Response Under 37 C.F.R. §1.111
Serial No.: 10/820,438
Response dated: March 10, 2006
In reply to the Office action mailed: November 10, 2005

Amendments to the Drawings

Remarks

FIG. 2

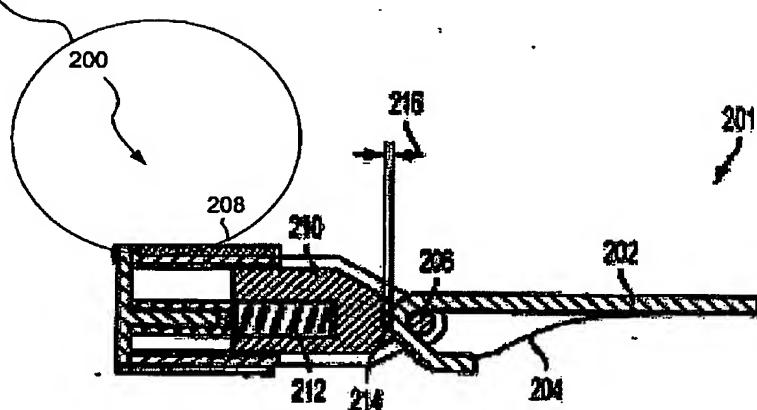
FIGS 2, 4, and 10 were objected to for not including reference signs mentioned in the specification. These figures have been amended to add the missing reference numerals, or where appropriate to replace an incorrect reference numeral with the proper reference numeral. The amendments are called out in the Annotated Sheets and reflected in the Replacement Sheets, appended hereto. No new matter is believed added by these amendments.

FIG. 2 has been amended to add the reference numerals 200 and 208.

FIG. 19

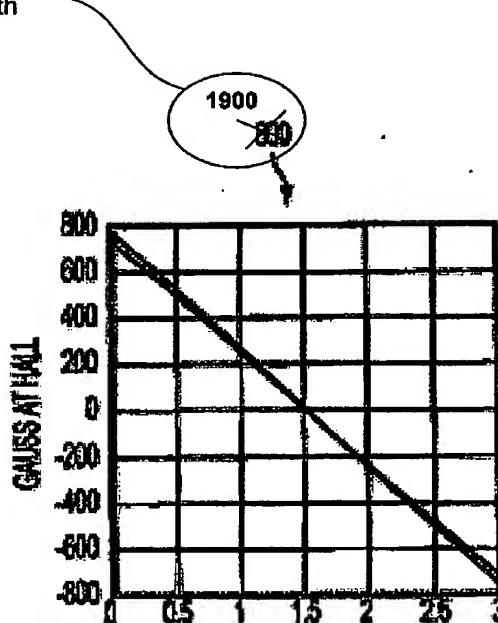
Reference
Numeral "800"
Replaced with
-1900-

FIG. 19 has been amended to replace the reference numeral "800" with --1900--.

FIG. 19 has been amended herein to replace the reference numeral "800" with the reference numeral "1900". The specification has been amended at paragraph [0057] to read consistently. No new matter is believed added.
